Air Tractor, Inc. Olney, Texas		ENGINEERING REPORT ORDER <table border="1" style="display: inline-table; vertical-align: middle;"> <tr><td> </td></tr> <tr><td>X</td></tr> </table>			X	NUMBER	REVISION
X							
#405							
TITLE SERVICE LETTER #405 Controls Interference on Certain AT-802 Aircraft		BY DDL		MODEL AT-802			
						CHK'D KS	
		DATE 12/29/2023		SERIAL See Below			
				PAGE 1 OF 3

Interference of AT-802 rear cockpit, left rudder pedal with the spray valve control pushrod reduces controllability and could lead to an accident.

Figure 1 – Rear Rudder Pedal Interference

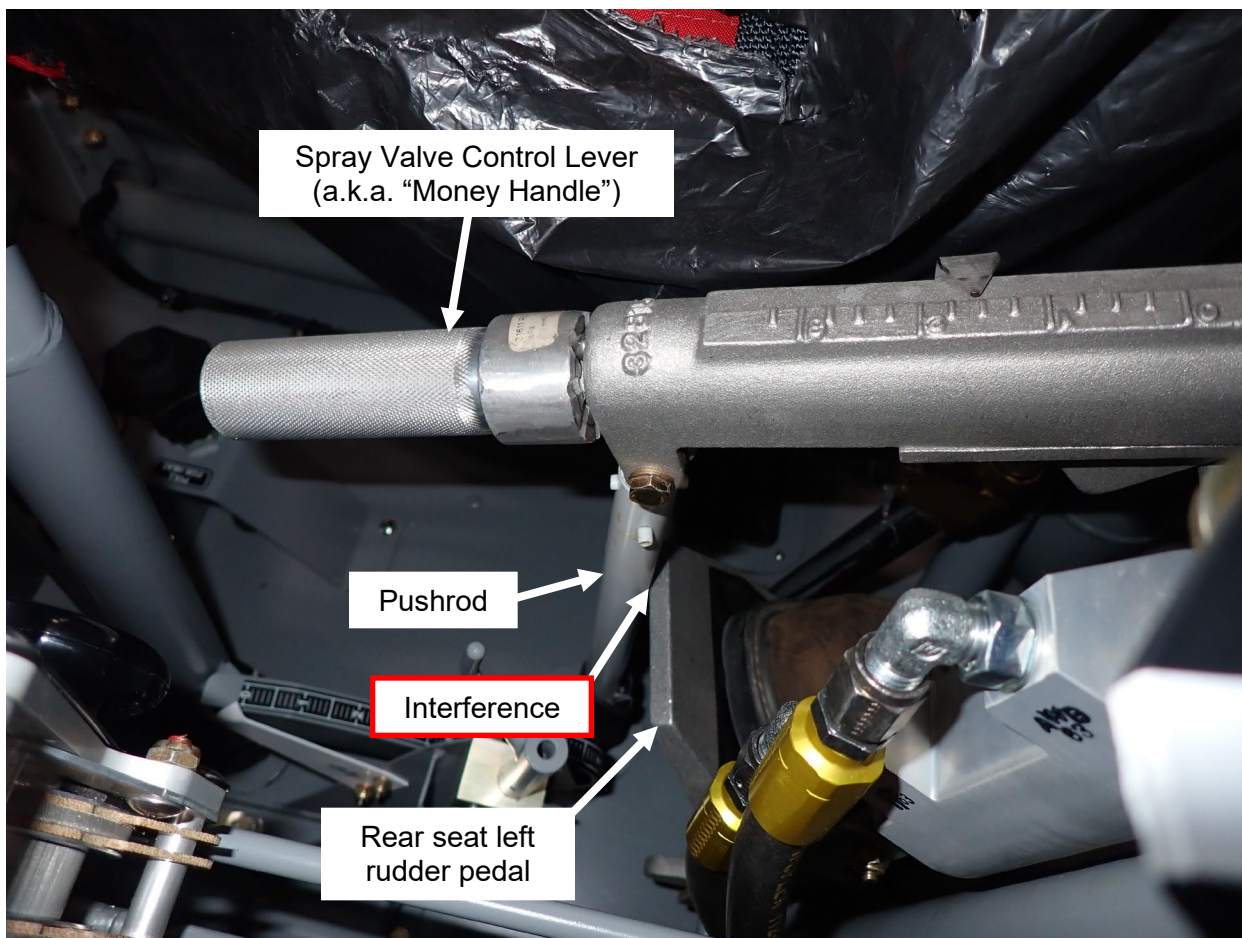
An investigation has revealed that interference of the spray valve control pushrod is possible. It is only possible however with the rear seat, left rudder pedal when the rudder pedal is in the forward adjustment position. This interference prevents simultaneous application of full left rudder and left brake (see Figure 1 below) when operated from the rear seat. This restriction in control could lead to a loss of control causing significant injury and aircraft damage.

Due to this interference, do not operate an affected aircraft with a pilot in the rear seat unless the rear pedals are in the rear-most adjustment position. Placement of the rear rudder pedals in the rear adjustment position is a temporary solution that will allow full, simultaneous application of left rudder and left brake. A bolt must be installed in the forward adjustment hole of the rudder pedal attach channel to prevent adjusting the pedal to the forward position.

Figure 2 - Rear Pedal Positioning

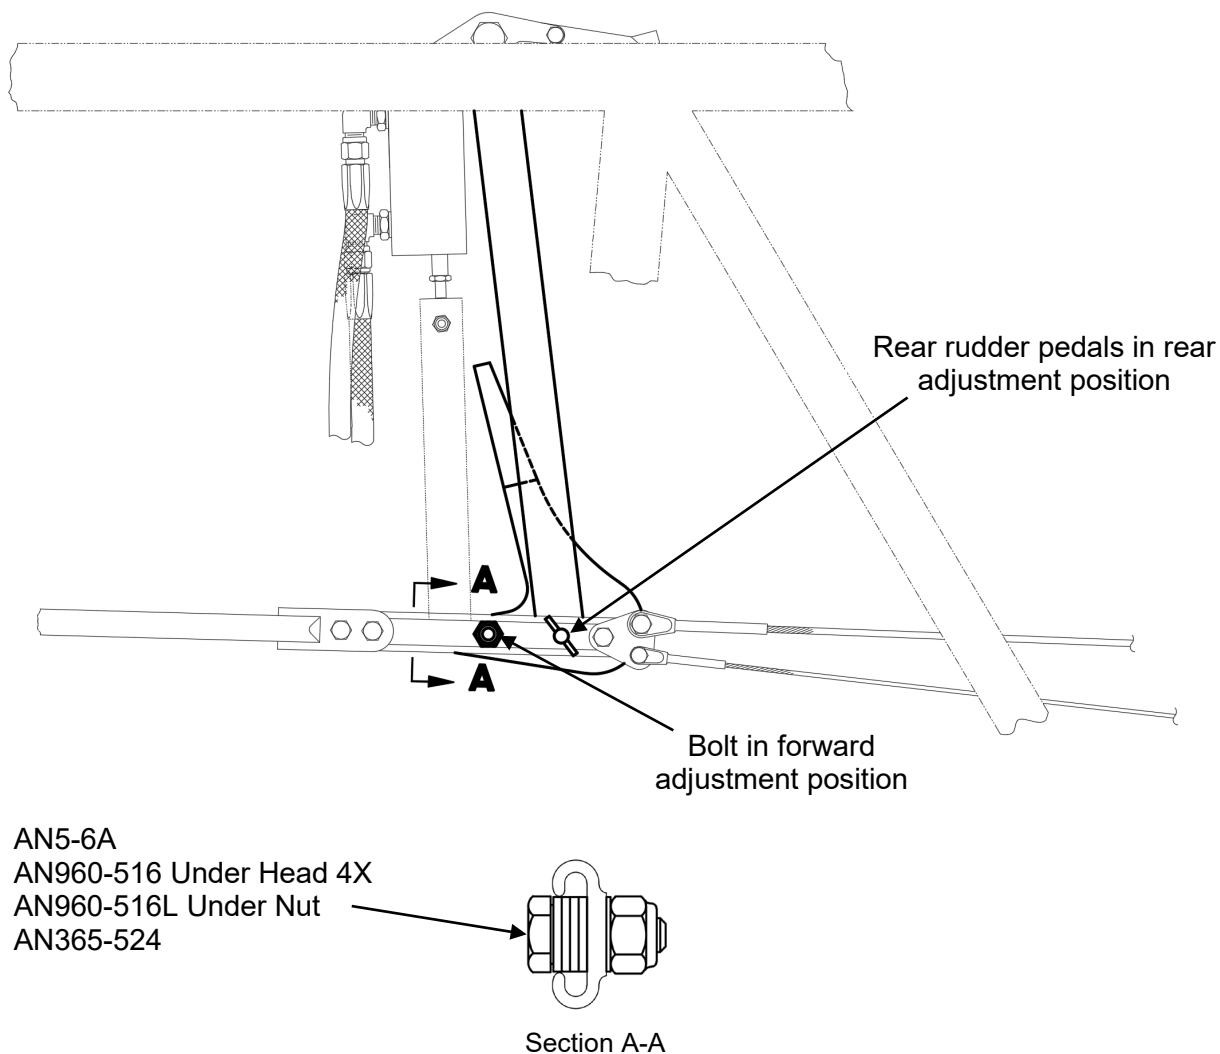
If the airplane IS equipped with both a spray valve control handle and rear cockpit rudder pedals, the rear cockpit rudder pedals must be moved to the rear-most adjustment location before operating the airplane.

An AN5-6A bolt shall be installed in the forward adjustment hole of both rear rudder pedal attach channels as shown in Figure 2 below.

After bolts have been installed, move the pedals and brakes through the full range of motion to ensure there is no interference.
